MODEL
2014-16MY Forte (YD)

NUMBER
157

TECHNICAL SERVICE BULLETIN

SUBJECT: ENGINE VIBRATION AT IDLE

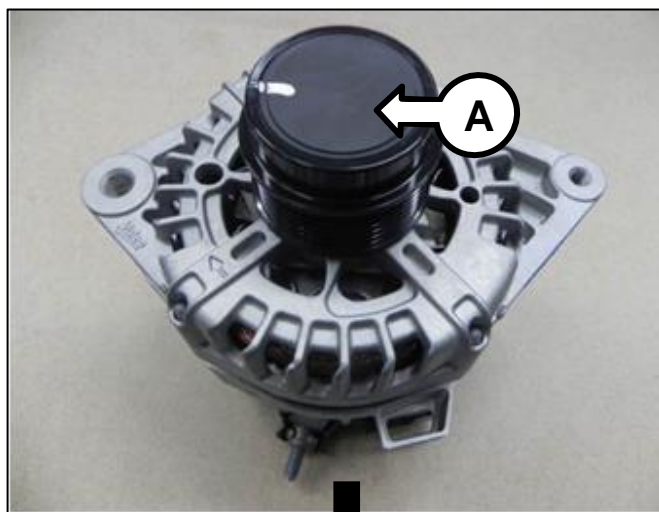
This bulletin provides the procedure to replace the alternator pulley. Some 2014-16MY Forte (YD) vehicles with 1.8L and 2.0L Nu engines may experience an unusual engine vibration at idle that is sometimes more prevalent under certain electrical loads. To correct this concern, replace the existing alternator pulley with a new one following the Service Procedure below.

Old

New

Part Name	Part Number		Remarks
	Previous	New	
Alternator Pulley			New components (solid type): Spacer, Pulley, Nut.
	37320-2E000	37320-2E010FFF

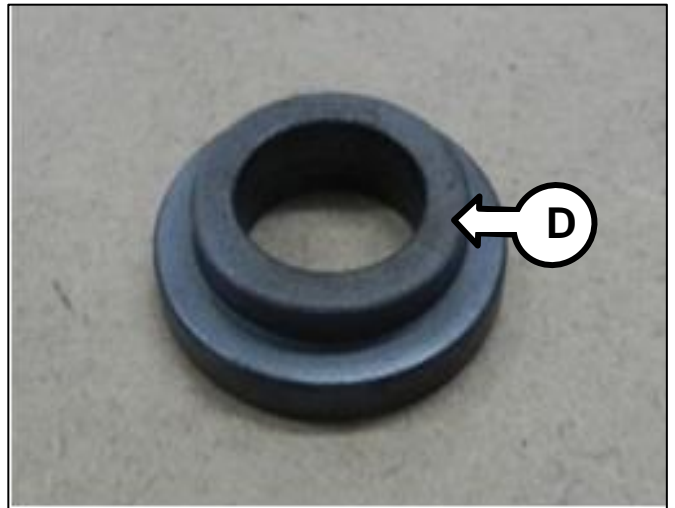
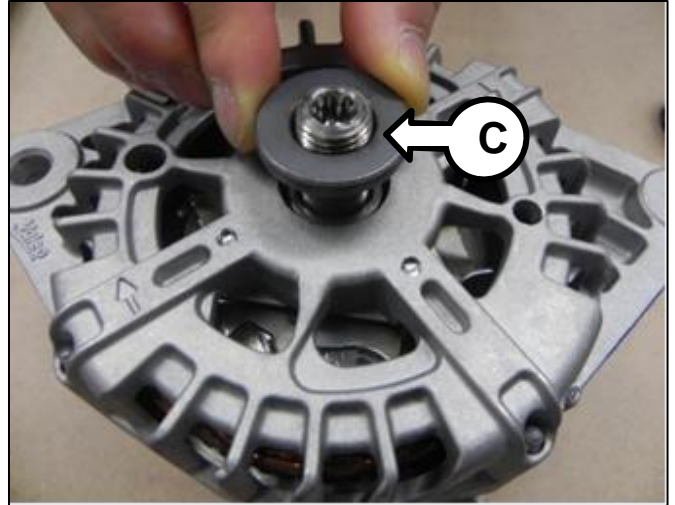
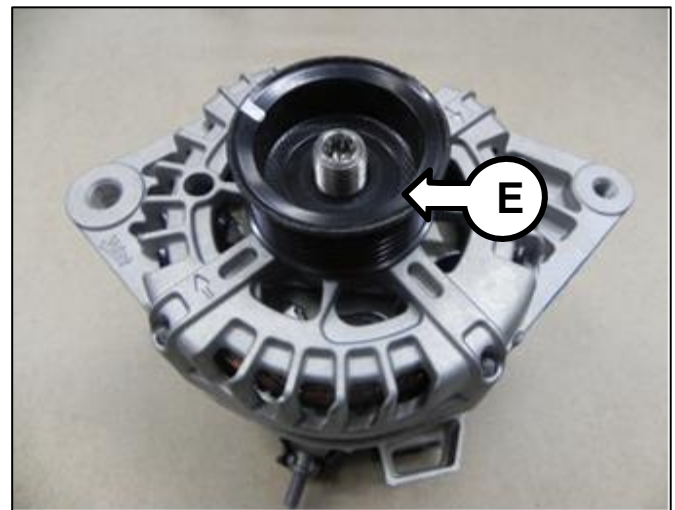
4. Install the new pulley spacer (C) onto the alternator as shown.

Install the spacer in the correct orientation. The lip (D) of the spacer must face the body of the alternator (flat side up.)

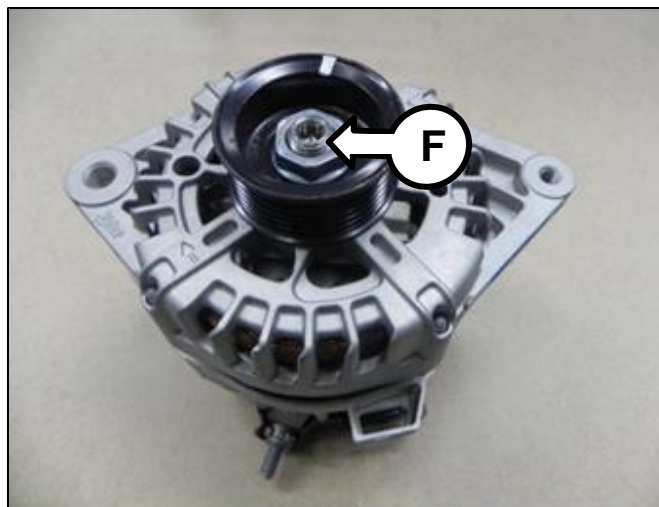
6. Tighten the new pulley nut (F) to the specified torque using a torque limiting impact extension, or equivalent tool.

Tightening torque:
59 lb-ft (80.0 N.m, 8.2 kgf.m)

After installing the new components, the belt tension measured between the crankshaft pulley and the air conditioner pulley is as follows:

637.4 ~ 735.5 N (65 ~ 75 kgf,
 143.3 ~ 165.3 lbf)

441.3 ~ 539.4 N (45 ~ 55 kgf,
 99.2 ~ 121.3 lbf)
